No. EL/3.2.85

Date: 22.01.2019

Modification Sheet No. RDSO/2019/EL/MS/0476 (Rev. '0')

Modification in Mounting arrangement of Leather Bellows of Traction Motors type 6FRA6068.

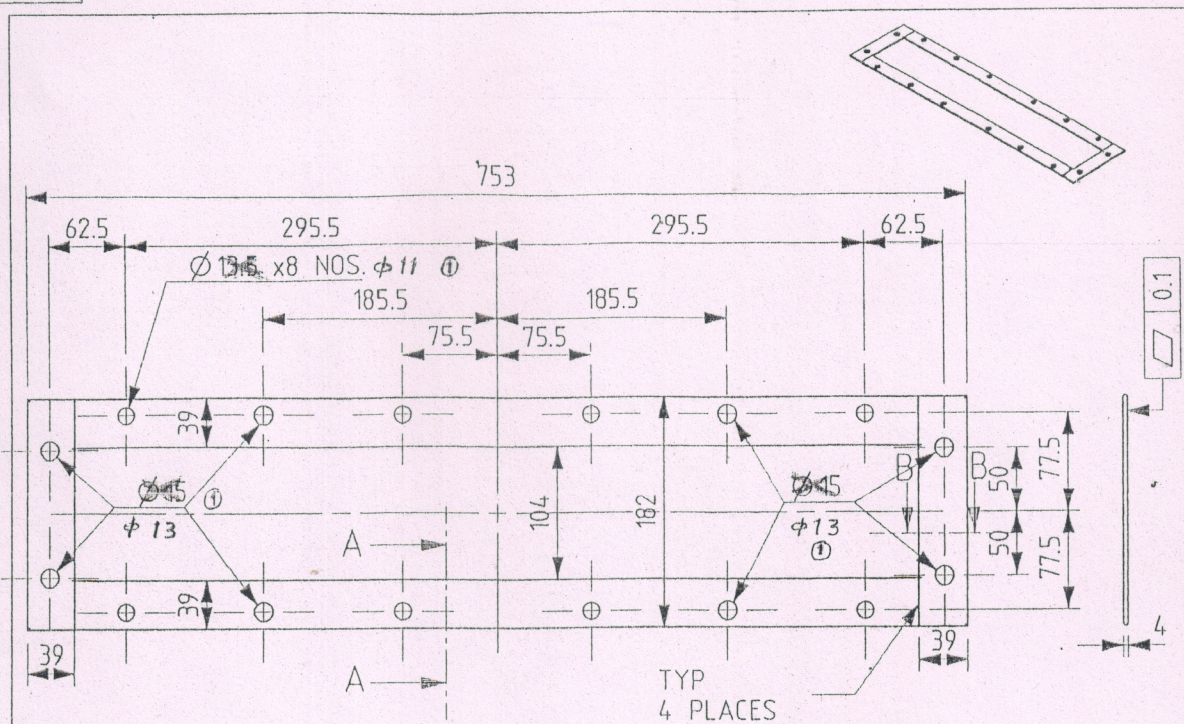
- (i) Remove the 22 mm step in drawing no. 1209-01.418-025 Alt '1' for modified bellow top plate for leather bellow, (Modified bellow plate for body side).
- (ii) Remove the 17 mm step in drawing no. 1209-01.418-027 Alt '1' for modified bellow bottom plate for leather bellow, (Modified bellow plate for TM side)
- (iii) Increase the thickness of modified bellow top & bottom plates from existing 3 mm to 4 mm in drawings numbers 1209-01.418-025 Alt '1' & 1209-01.418-027 Alt '1'
- (iv) Inner and outer edges of Modified bellow Top & Bottom plates to be made half round with 2.0 mm radius.

- 3.1.1. Tighten the modified plate flange traction motor inlet as per CLW's drawing number 1209-01.018-26 alt. '1'. The modified plate is having 8 numbers of counter sunk holes for fixing base plate of end shield. The modified plate to be fixed with Hex. Socket CSK Head Screws as per RDSO's Modification sheet number RDSO/2018/EL/MS/0472 (rev '0') dated 20.08.2018. This modified spacer plates can be welded on end shields.
- 3.1.2. Use single duct leather bellow as per CLW's drawing number 1209-01.018-029 Alt. '0' along with modified bellow bottom plate (TM side) as per CLW's drawing number 1209-01.418-032 Alt. '0' to secure the bellow at traction motor end with the help of 12 mm size bolt.
- 3.1.3. Provide modified top plate (body side) as per CLW's drawing number 1209-01.418-031 Alt. '1' to secure the bellow properly with locomotives body.

1. ALL DIMENSIONS ARE IN MM.
2. PU PAINT BLACK GREY RAL7021.
3. ALL SHARP EDGES TO BE REMOVED.
4. THIS DRG. SUPERSEDE DRG. NO. 1209-01.418-025.
5. REF. ASSLY DRG. NO. 1209-01.318-024 REF.2.
